SERVICE LETTER

SL 2003-3
ATA 5711

SUBJECT: **OUTBOARD WING SPAR ATTACH BOLTS**

MODEL / SERIALS AFFECTED: AG-5B S/N 10203, 10204, 10207 and S/N 10209 through 10215

Figure 1

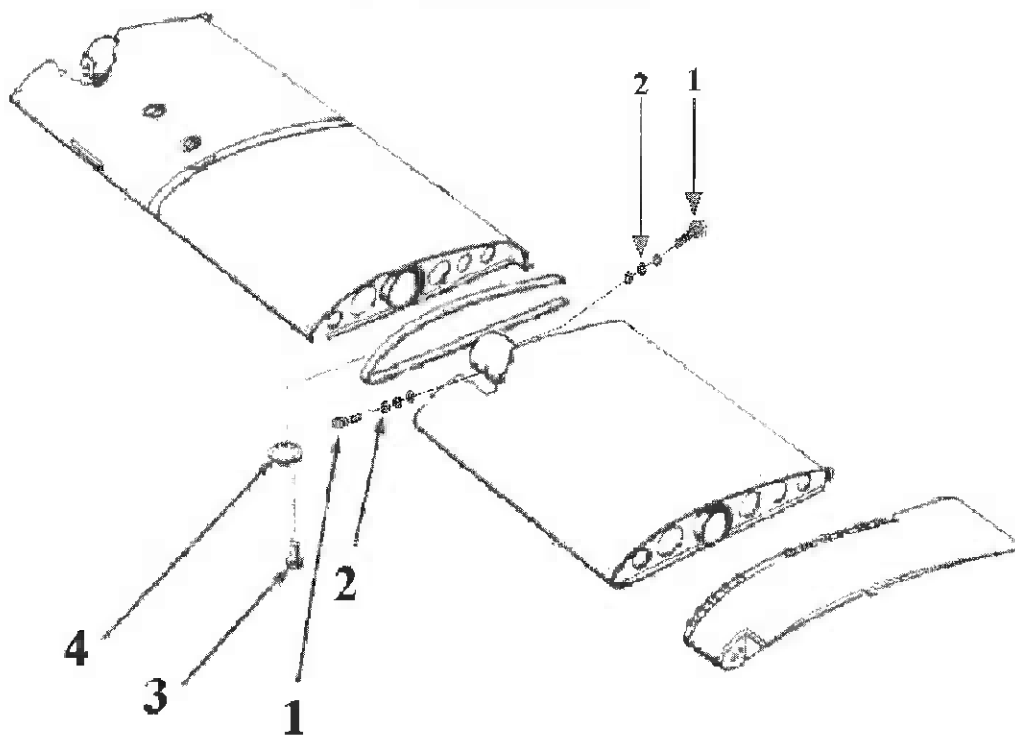
2. Remove the access panels forward and aft of the outboard spar attach point and locate the outboard spar attach bolts. (Figure 1)
3. Visually inspect the spar attach bolts and determine the bolt type. (Figure 3)

1. Forward Access Panels
2. Aft Access Panels

1. 901044-1 Shoulder Bolt or AN8-10A Bolt
2. AN960-616 Washer (3) or AN960-816 Washer (1)
3. Screw
4. Access panel

Figure 2

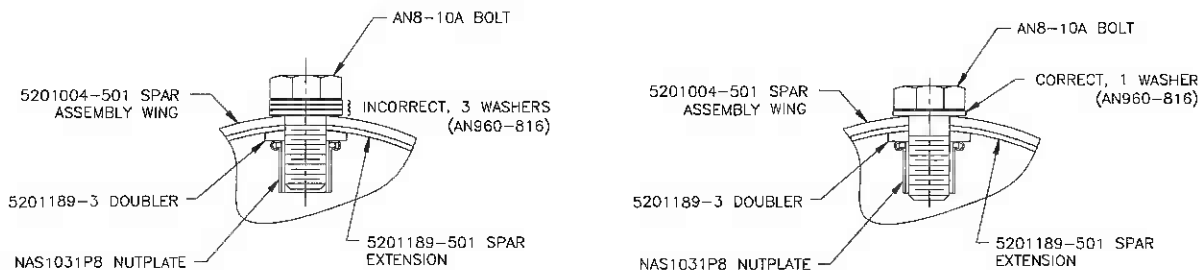
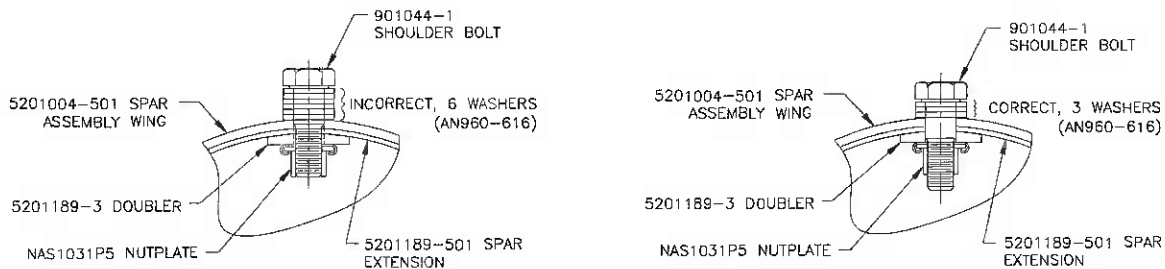
The standard method of attachment of the outboard wing panel is the use of two (2) P/N 901044-1 Shoulder Bolts, one on either side of the spar. These shoulder bolts should have three (3) AN960-616 washers under the head of each bolt. It has been determined that six (6) washers may have been installed under the head of each Shoulder Bolt during the manufacturing process. (Figure 2)

One or both wings installed on the affected aircraft may have their outboard wing panels attached using an alternate method of attachment. This method uses two (2) AN8-10A bolts with one (1) AN960-816 washer each in the place of the 901044-1 bolts and AN960-616 washers. It has been determined that three (3) AN 960-816 washers may have been installed under the head of these bolts during the manufacturing process. (Figure 2)

4. If 901044-1 shoulder bolts are found, determine the number of AN960-616 washers installed under the head of each bolt.
 - a. If three (3) washers are installed under the head of each bolt (Figure 2), no further action is required. Comply with steps 12-14.

- b. If six (6) washers are installed under the head of each bolt (Figure 2), proceed with steps 6-14.
5. If AN8-10A bolts are found, determine the number of AN960-816 washers installed under the head of each bolt.

- a. If one (1) washer is installed, no action is required. Comply with steps 12-14.
 - b. If three (3) washers are installed under the head of the bolt (Figure 2), proceed with steps 6-14.

9. Reinstall the 901044-1 shoulder bolts with three (3) AN960-616 washers under the head of each bolt and torque to 60-85 inch pounds.
10. Reinstall the AN8-10A bolts with one (1) AN960-816 washer under the head of each bolt and torque to 290-410 inch pounds.
